Technical Service Bulletin

Trifecta® X-series Red Lion Change

TSB-HPS-1022

To Change out the controller:

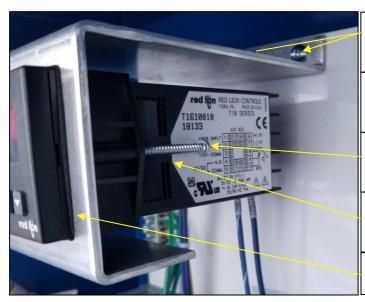
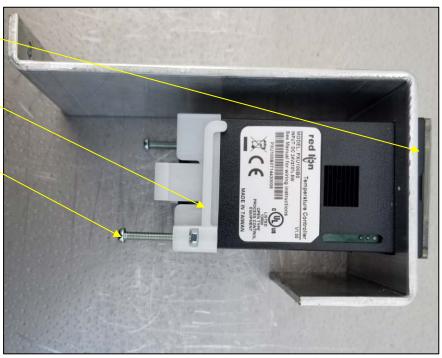
<u>Description:</u> A few ways to differentiate between the two controllers is that the old Red Lion has four buttons on the face and the new model has six. (See picture below).

You need to remove the two Philips head screws that hold the Red Lion bracket on.

Remove the wires from the back of the controller.

Loosen the two screws on the side of the controller once it is removed.

Pry up on the plastic tabs on the side and then slide the clamp off the back.

Slide the Red Lion controller out of the front of the bracket.

Slide the new Red Lion controller into the front of the bracket.

Slide the white clamp onto the back of the Red Lion controller until it clicks in place and is holding the Red Lion controller firmly into the front of the bracket.

Snug up the screws on the corners.

Red Lion Controller wiring

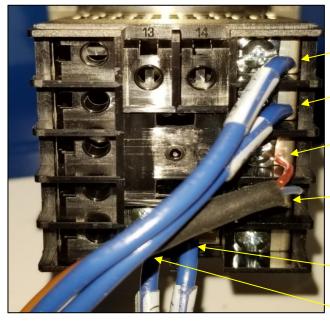
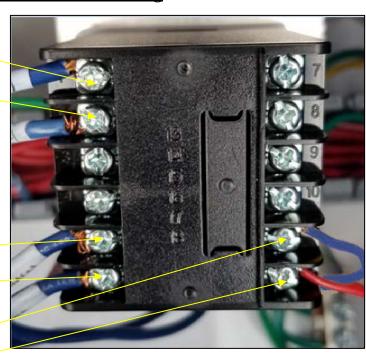
Issue: Recently Red Lion discontinued the T1610010 temperature controller in the Trifecta control box. We are replacing it with the PXU100B0 (Chart P/N 21323109). Due to the difference between the two controllers, the wiring is slightly different.

Listed below are diagrams that show how to wire both versions of the controller.

Terminal 6 normally open Contact 24v+ (104+)

Terminal 7 normally open Contact Signal wire (223)

Terminal 8 (TC-) Red wire

Terminal 9 (TC+) Blue wire (yellow on some units)

Terminal 12 Negative wire 24V- (105-)

Terminal 11 Power wire 24V + (104+)

New Red Lion Controller wiring

Terminal 1 Power wire 24V + (104+)

Terminal 2 Negative wire 24V- (105-)

Terminal 5 normally open Contact (104+)

Terminal 6 normally open Signal wire (223)

Terminal 11 (TC+) Blue wire (yellow on some units)

Terminal 12 (TC-) Red wire
